SERVICE LETTER

ANTENNA LOCATION AND FLIGHT MANEUVER CAUTION

RECOMMENDED HELICOPTER REWORK

Figure 1. Recommended Antenna Location

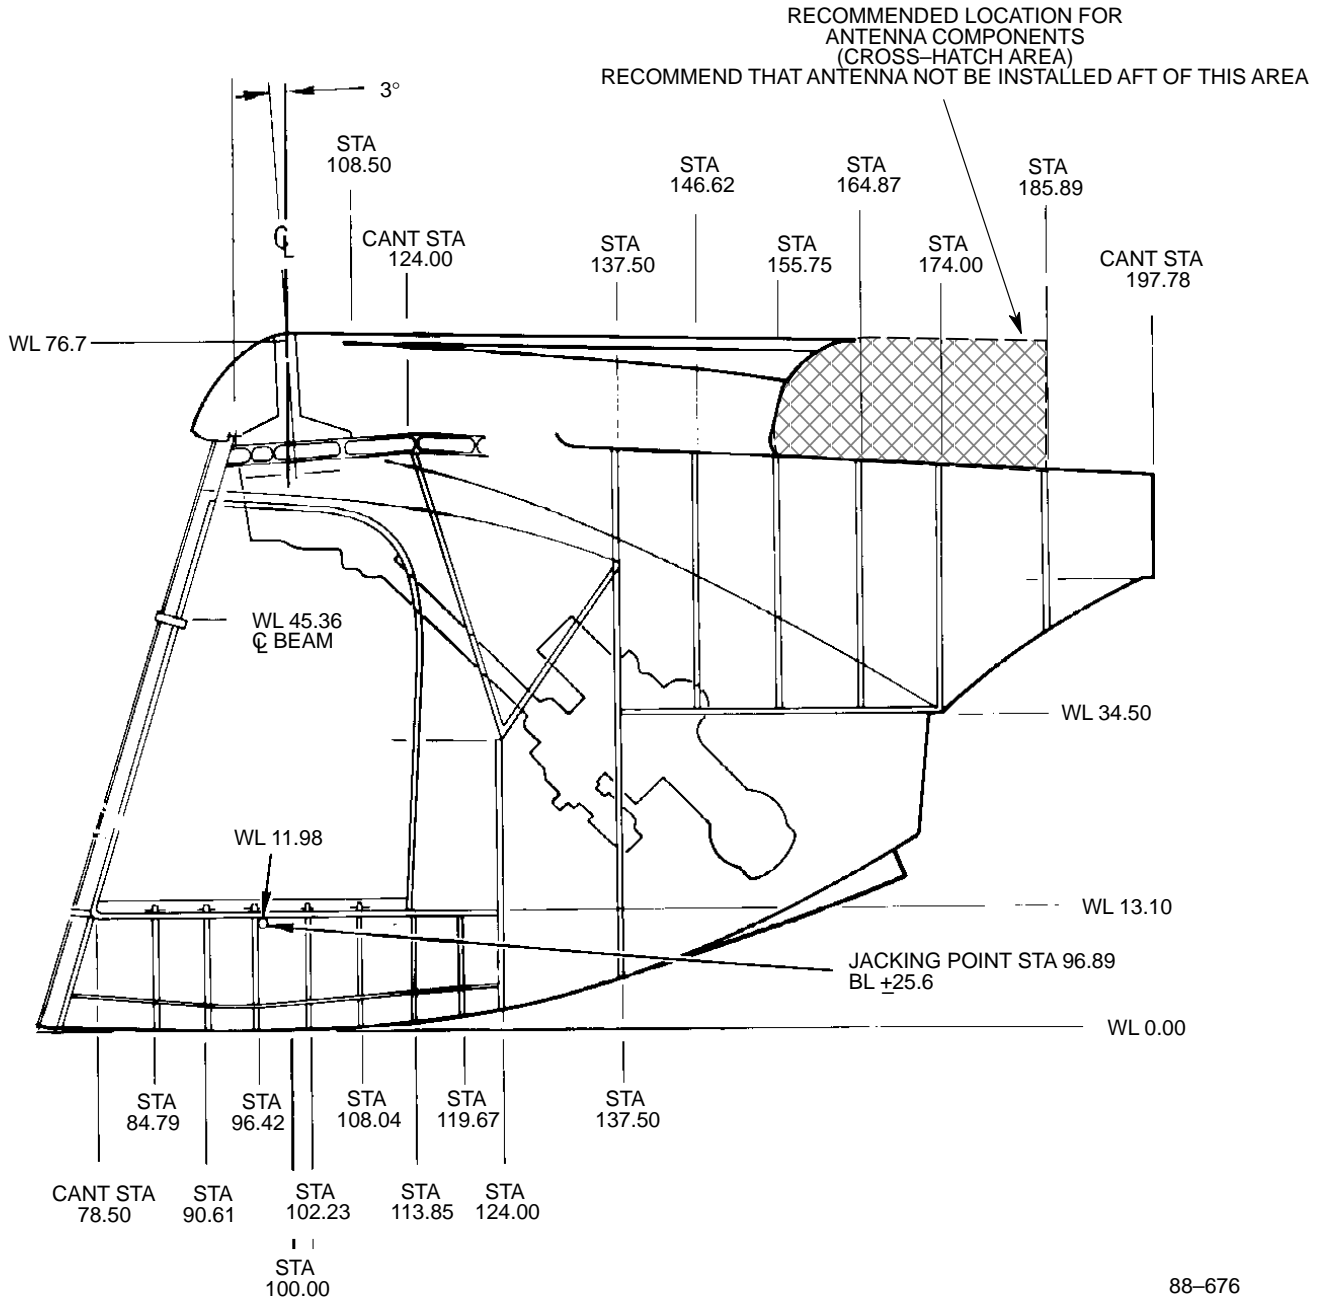
MDHC has received information from operators indicating that antennas (e.g., LORAN antennas) installed on the upper surface of the aft boom fairing have been struck by the main rotor blades during practice touchdown autorotations. MDHC strongly recommends that operators who have installed antennas on the upper surfaces of the aft boom fairing relocate those installations to a position where contact between any rotating component and an antenna will not be possible. Figure 1 shows an acceptable location for such installations.
